UNIVERSITY OF KENTUCKY Purchasing Division

INVITATION FOR BIDS

ADDENDUM# 8

H46 STEAM PIPING REPLACEMENT			
SCALE	DATE	PROJECT	PROJ. NO.
AS NOTED	08-31-2022	CHANDLER MEDICAL CENTER	111300HSR22

PRESSURE REDUCING VALVE STATION PIPING DETAIL

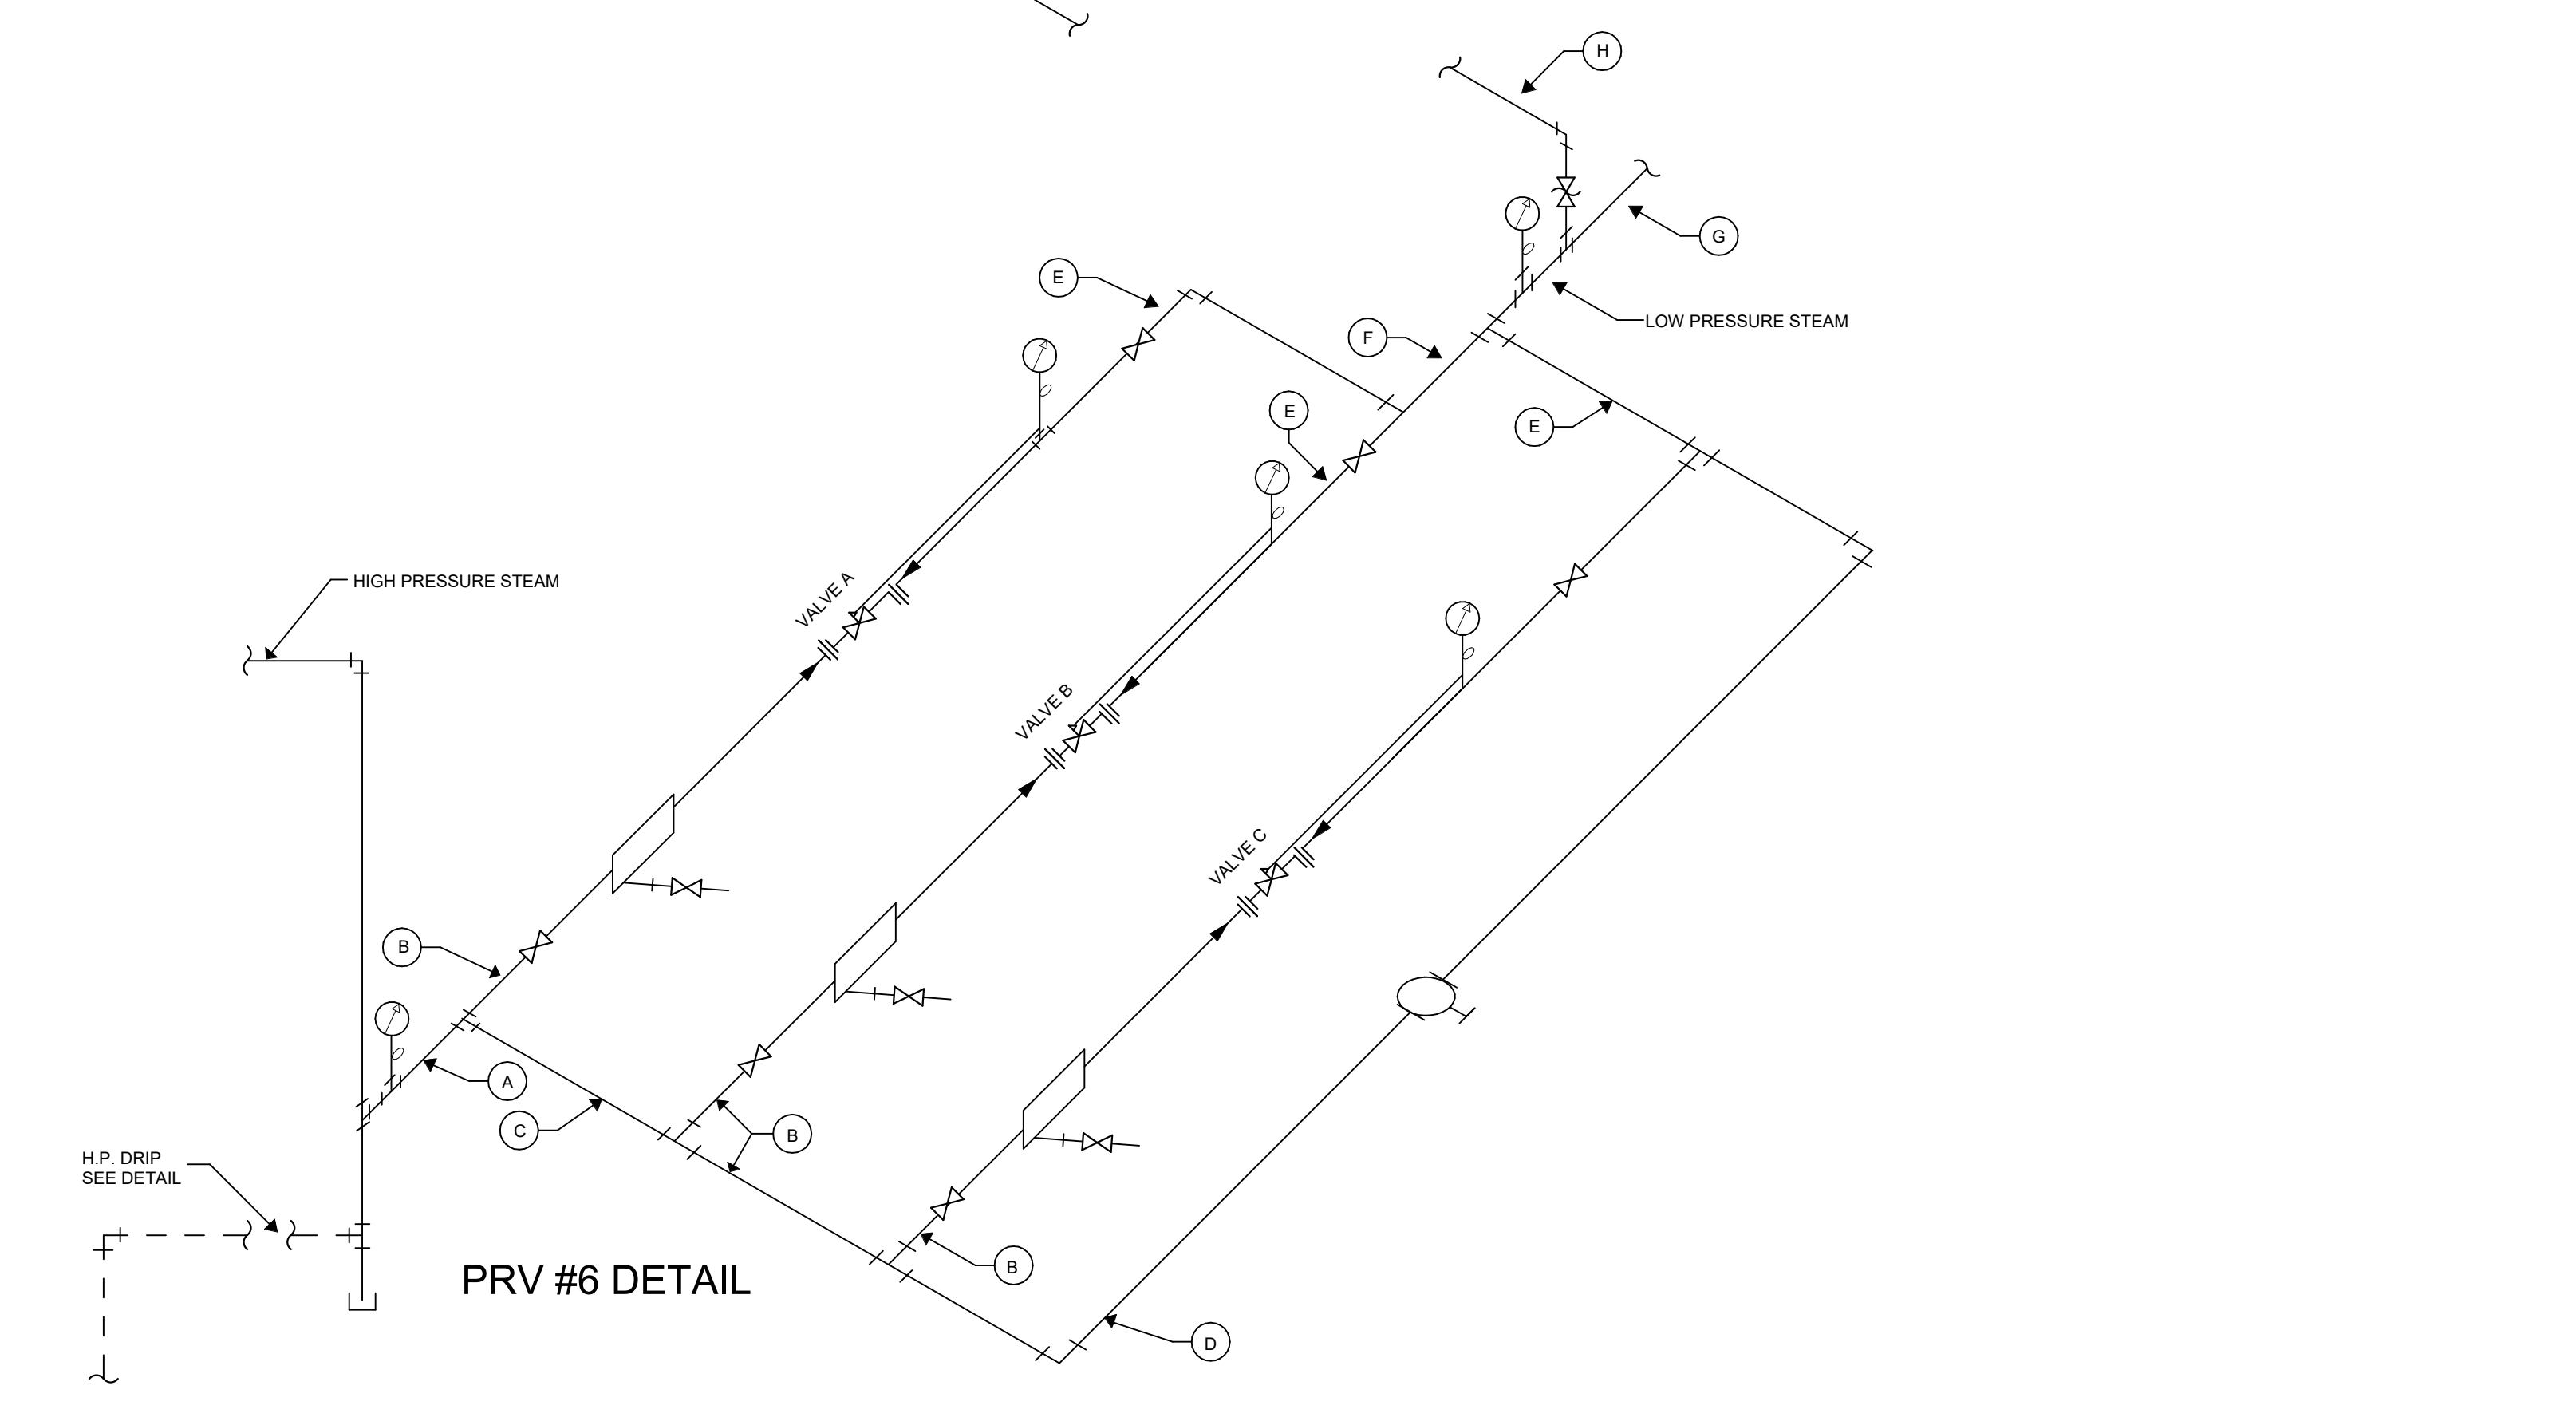
Question Date	Question #	Question	Responder	Response
2/28/2023	1.	Are the complete PRV stations and steam coil hook ups to be demoed and replaced? Please confirm, the drawings are confusing, because the demo to symbol and connect to existing say otherwise.	CMTA	Refer to addendum #5 and #8 drawings for demolition scope of prv and coil connections.

2.	Do the PRV station #1,2,4,5,6 get completely replaced ?	CMTA	Refer to addendum #5 and #8 drawings. PRV stations #1, #2 and #6 are replaced complete in their respective phases. #4 and #5 only piping to the PRV.

3.	Any work associated with PRV #3, it appears on the schedule, but not on drawings is it included in this project?	CMTA	Refer to revised m3.0 addendum #8.

4.	Please schedule PRV #5 sizes.	CMTA	Refer to revised m3.0 addendum #8.
	5.	Please provide pipe sizes "D,E,F,G,H" for PRVs 1 & 4.	CMTA	Refer to revised m3.0 addendum #8.

6.	Is the upper detail of the PRVs shown on drawing M3.0 for PRVs 2,3, & 5?	CMTA	Refer to revised m3.0 addendum #8.
	7.	We assume any asbestos abatement will be handle by the owner	CMTA	Yes

PRV NO.	LOCATION	ENT STEAM PRES.	VALVE A		VALVE B		VALVE C		PIPE SIZES								
			SIZE	#/HR PRES.	SIZE	#/HR PRES.	SIZE	#/HR PRES.	(A)	(B)	(C)	(D)	(E)	(F)	(G)	(H)	
1	H-46	160 PSI	1 1/2"	3750 14 PSI	1 1/2"	3750 13 PSI	-	-	-	3"	6"	2"	-	-	-	-	-
2	H-46	160 PSI	1 1/2"	4052 14 PSI	1 1/2"	4052 13 PSI	1 1/2"	4052 12 PSI	4"	6"	2 1/2"	-	-	-	-	-	
4	H-46	160 PSI	1"	1580 60 PSI	-	-	-	-	2 1/2"	3"	1"	-	-	-	-	-	
5	H-46	160 PSI	1"	1600 25 PSI	-	-	-	-	2 1/2"	4"	1"	-	-	-	-	-	
6	H-46	160 PSI	1 1/2"	4160 7 PSI	1 1/2"	4160 6 PSI	1 1/2"	4160 6 PSI	5"	3"	4"	3"	6"	8"	8"	8"
